Architectural Review Board Meeting Agenda

Thursday, July 11, 2024 at 5:30 p.m.

1. Project: Bono Duplex Addition & Remodel, Project 23-2237-CUP/CDP/ARB
Address: 4788 & 4792 Dorrance Way
Applicant: Dylan Chappell, architect, for Brandon Bono
Planner: Syndi Souter

2. Project: Pfaff New Residence, Project 23-2209-ARB/CDP
Address: 5559 Calle Arena
Applicant: Jon Starr, designer, for Mark and Megan Pfaff
Planner: Syndi Souter

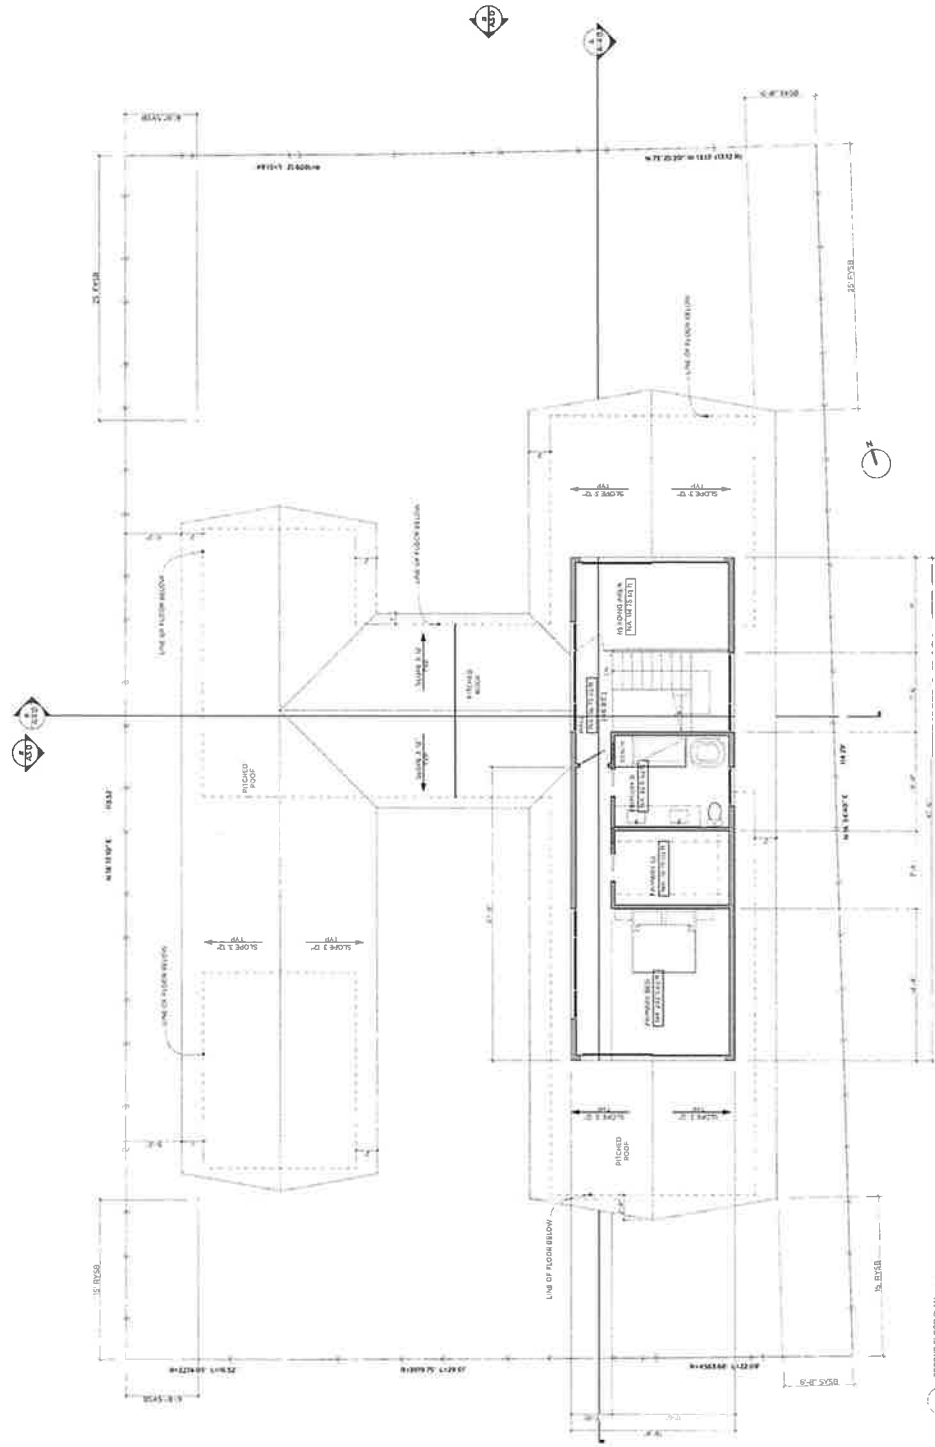
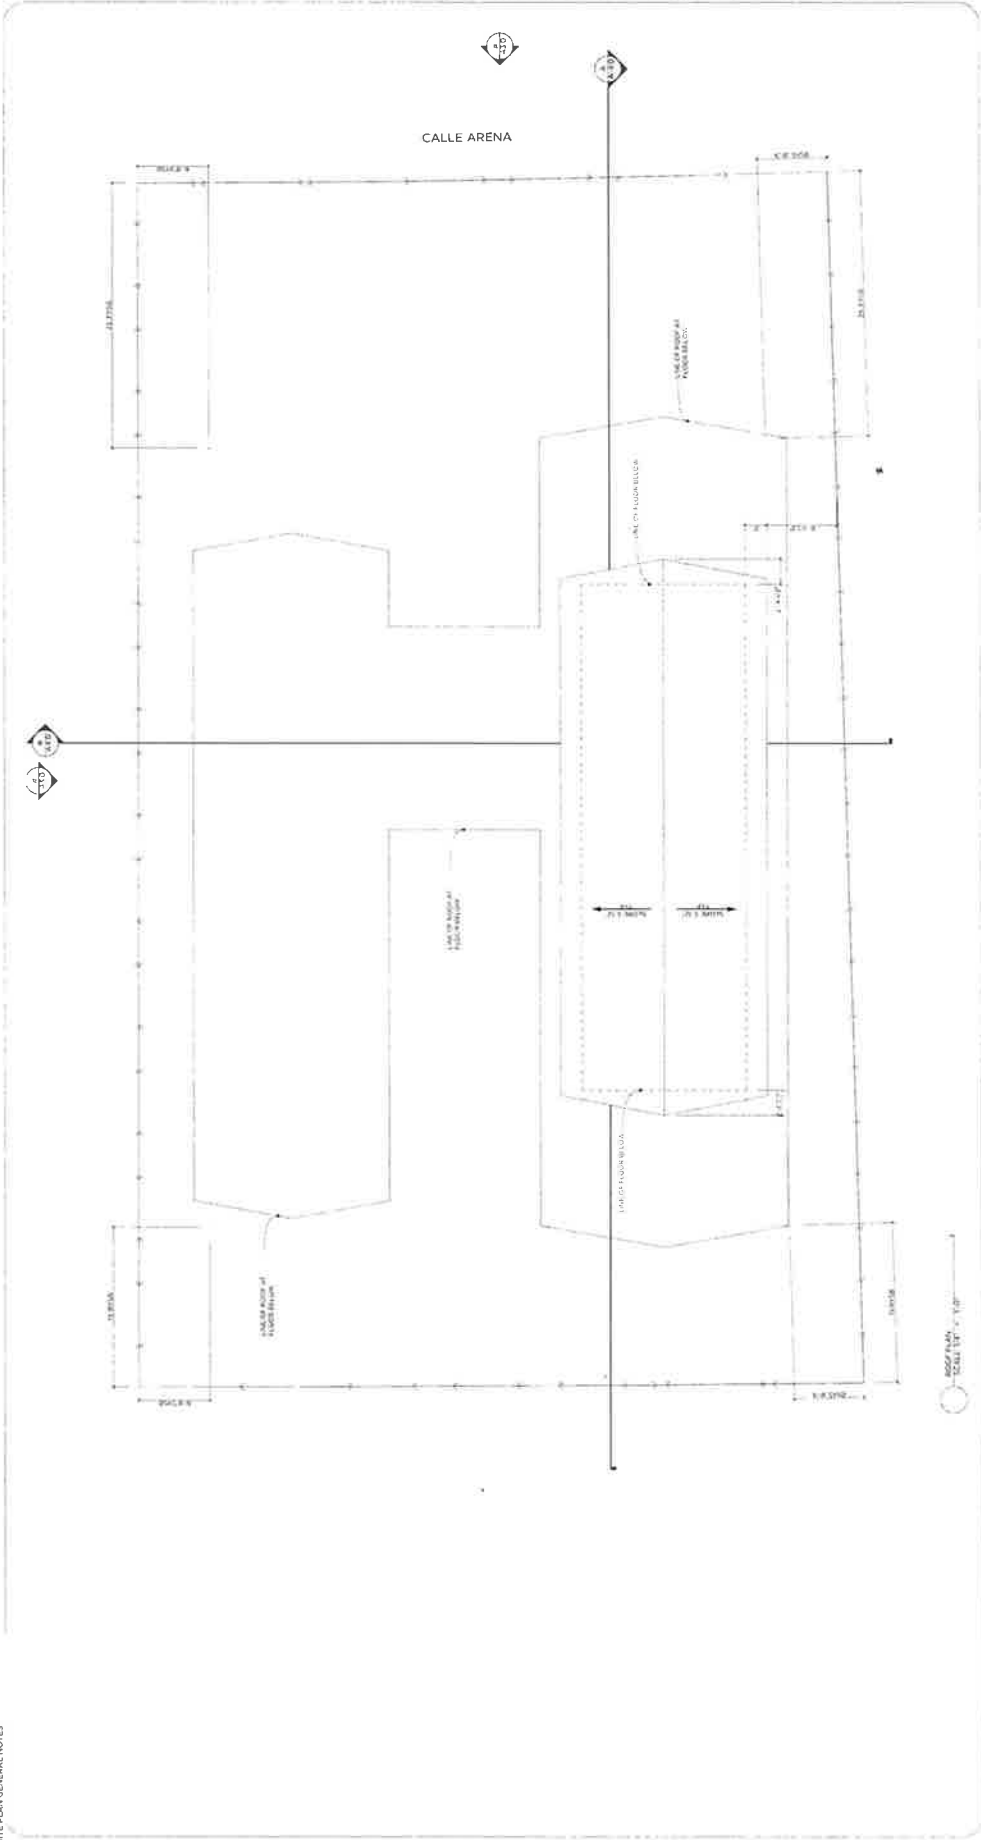
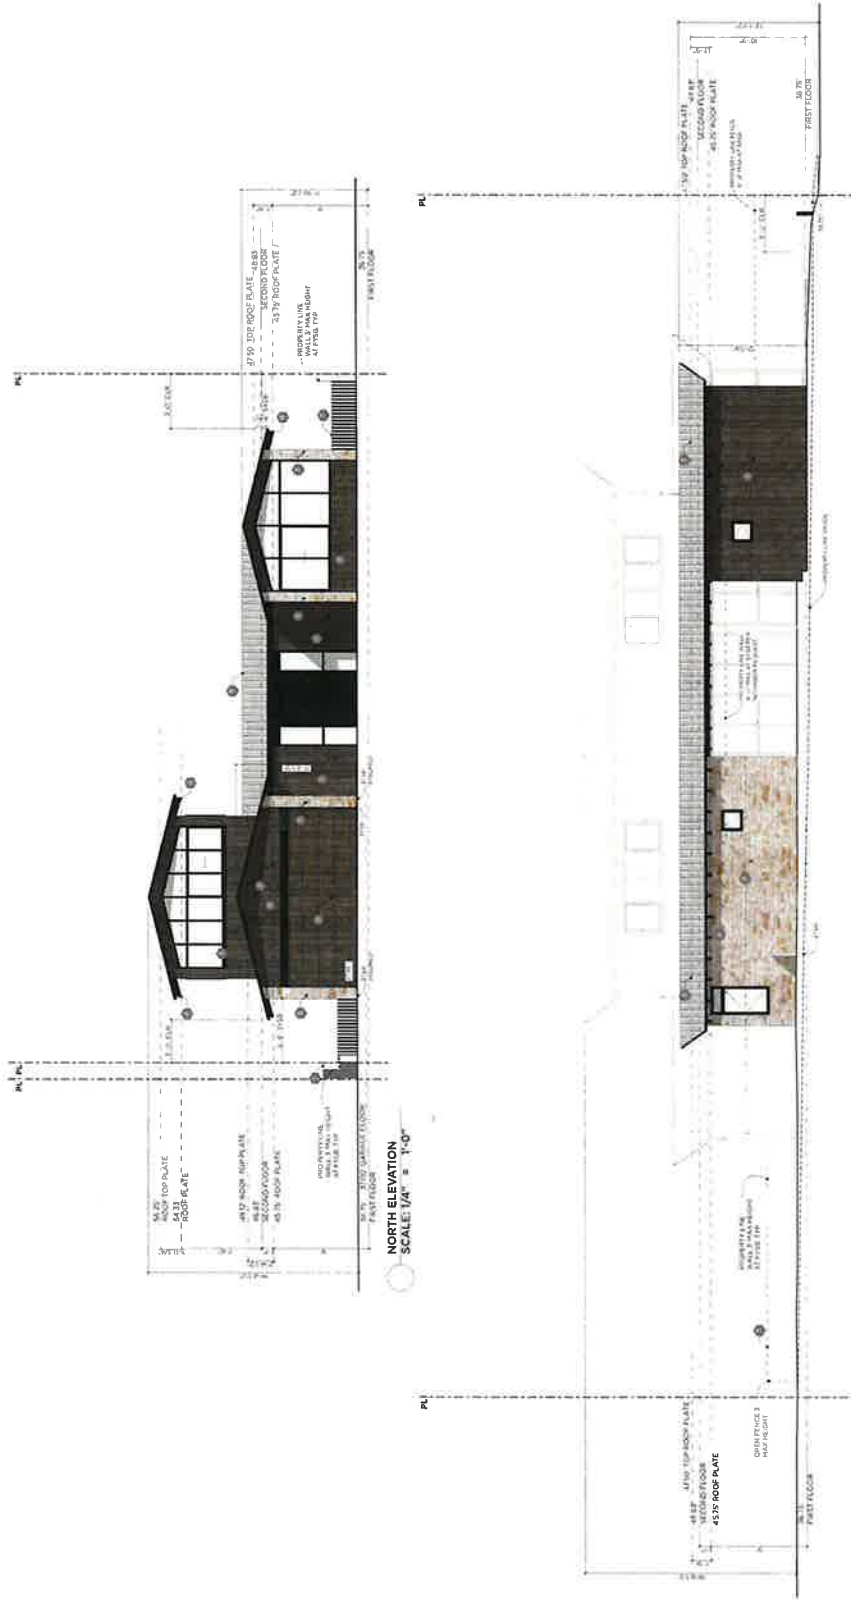
The proposed large gable end windows, especially the ones on the second story, could spill light out onto the surrounding area. The windows have been modified to include more lights, but the window sizes remain the same. The windows on the north elevation, facing the street, are the primary concern. Measures should be taken to either reduce the amount of glazing or to provide dark tinting on the gable end windows to prevent spillover.

In response to the ARB comments, a lighting plan has been prepared for the property. The plan, as shown on Sheet L-4, includes site and pathway lighting for the new residence. The plan does not specify any exterior light fixtures for the residence. The lighting plan does include directional up-lights along the sides of the residence, which would illuminate the residence at night. The up-lights, combined with the light spillover from the large windows, may cause photo pollution in the neighborhood.

The Board should provide comments on the proposed windows and lighting plan.

In response to Boardmember Johnson, we have dropped the floor of the house, and will ensure that drainage is properly maintained to avoid flow onto neighboring properties. We have divided the larger windows to bring down the scale as requested, and note that as shown in the building sections A4.0, we have upper floor sill heights at 3'-6" (although sinking the floor down into the lower roof may make them appear lower). We have lowered height on both floors as suggested, which also addresses some of Boardmember Little, Boardmember O'Connor, and Chair Stein's concerns over height. We also note that other than the garage, the main mass of the house is set back 35' from the property line, in order to create a less imposing street presence. We have also removed the more modern flat roof of the center entry area with a pitched roof to break up the unidirectional nature of the roofs.
